Zoning Staff Report

Case Number: ZC-24-063

Zoning Map Amendment & Site Plan

Proposed Use: Townhouses

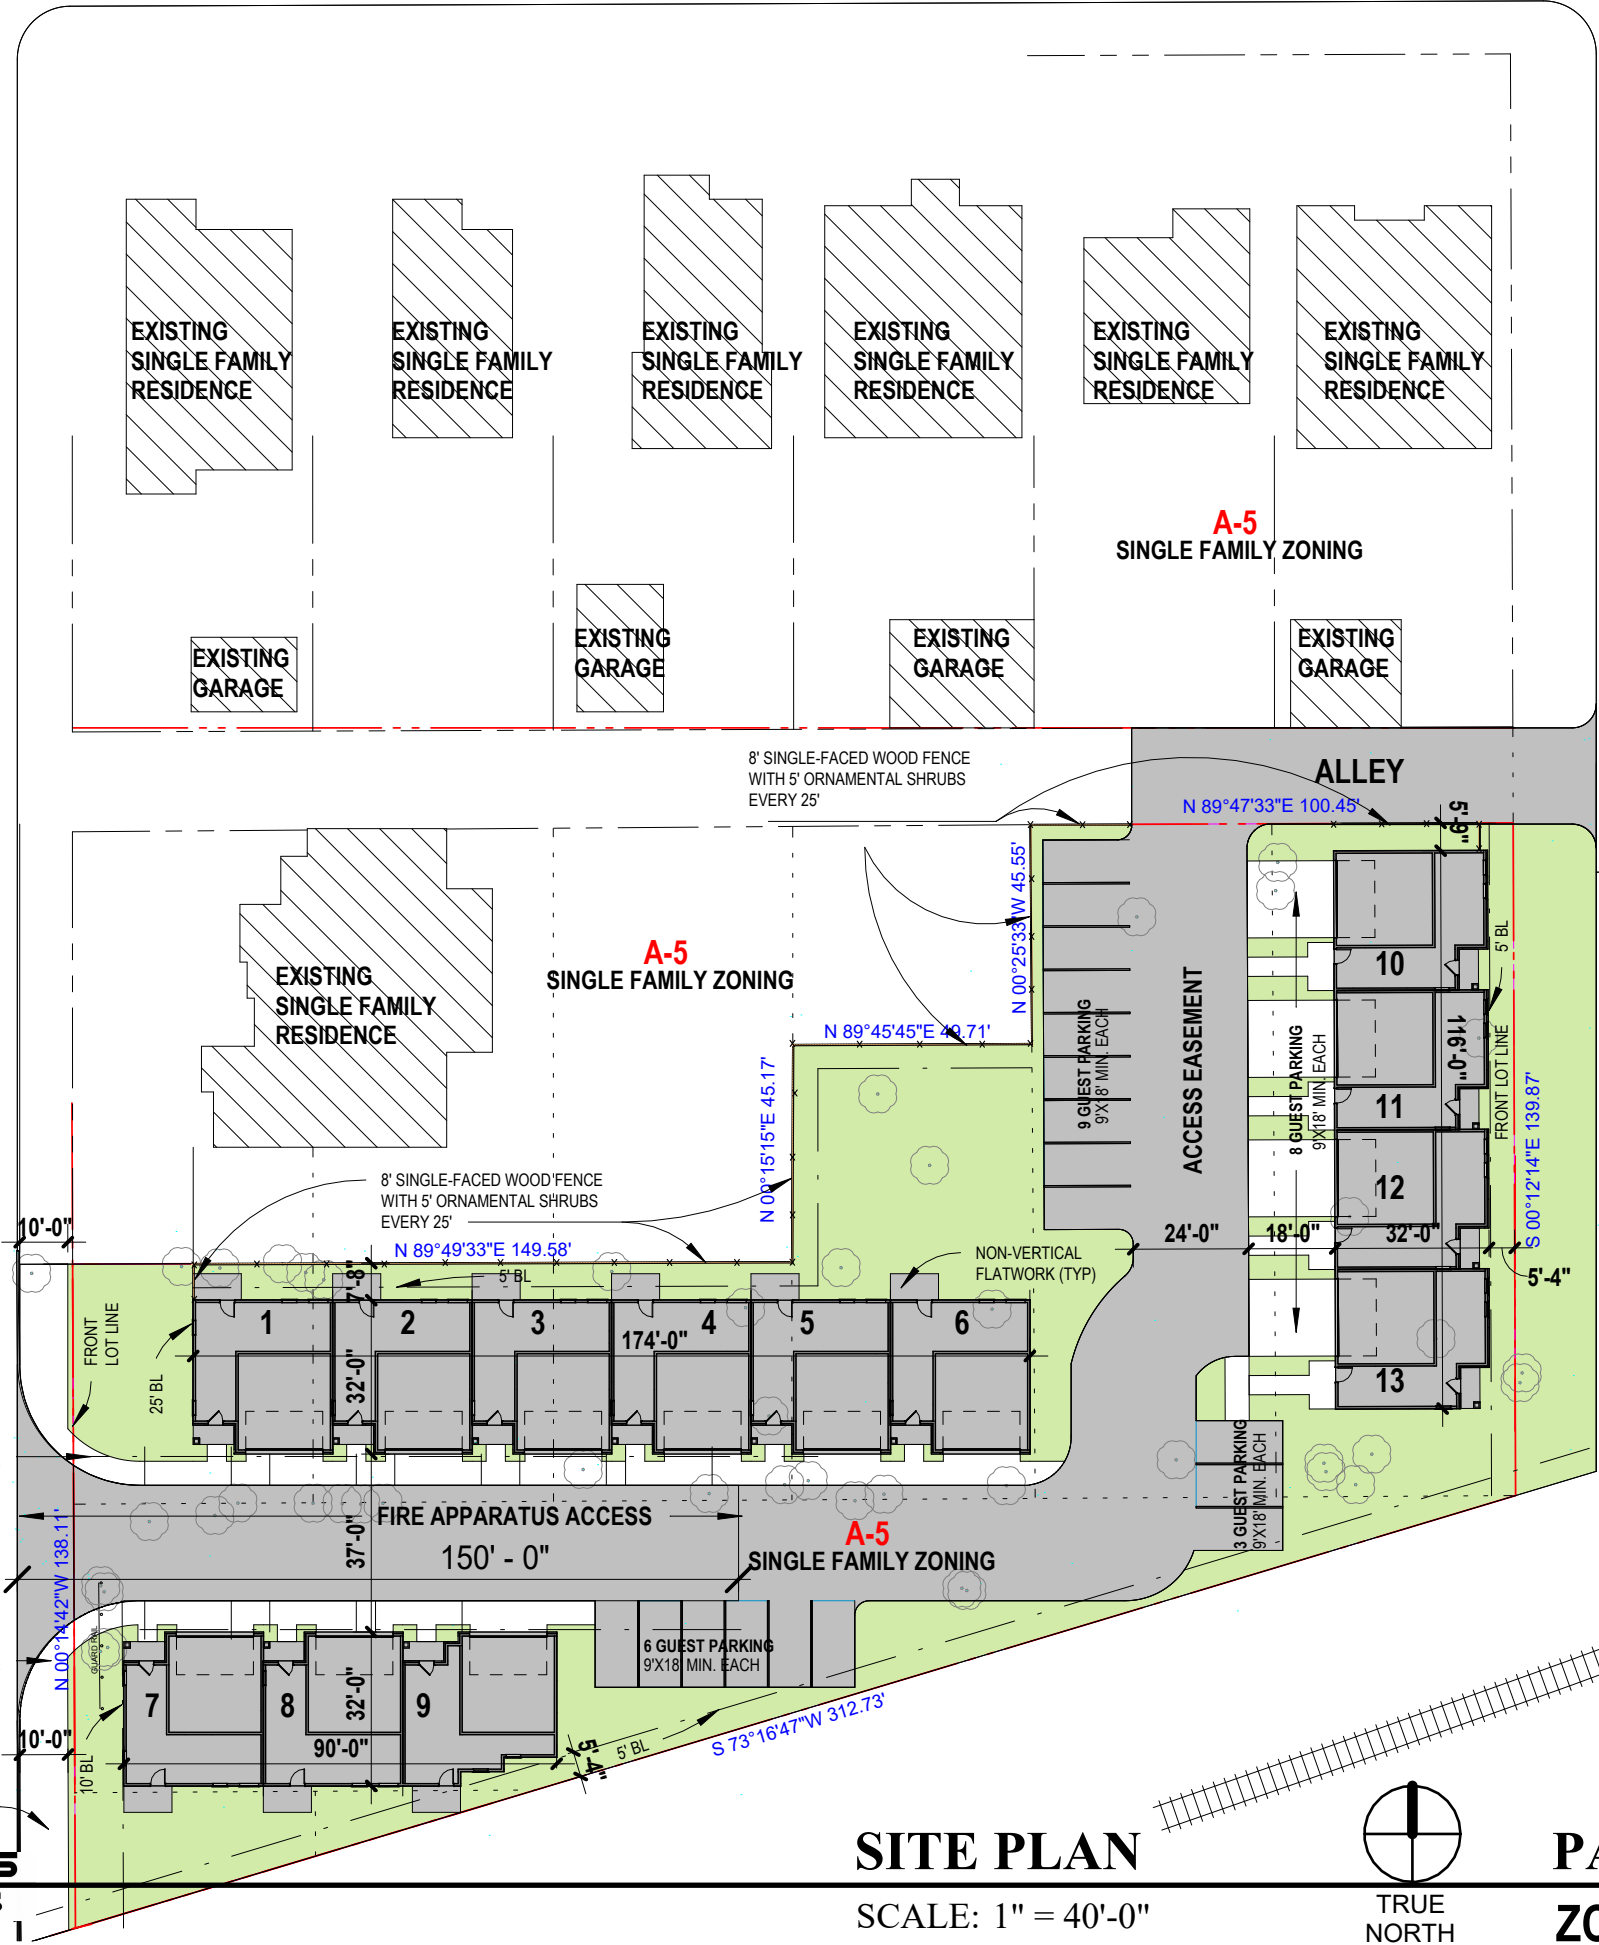
FYI: Per site plan provided the following will be needed.

1. 20ft. Fire lanes thru out the complex.
2. Possibility of adding a fire hydrant
3. Alley paved to current fire code standards

Site has potential high water that can get up to 5 ft deep. No FEMA Floodplain or City Flood Risk Area on site.

Storm Infrastructure is located along Lawnwood St per TPW Plan Set S-0602, K-1018, & K-0133.

An accepted drainage study is required prior to platting, commercial grading issuance, and building permit issuance.
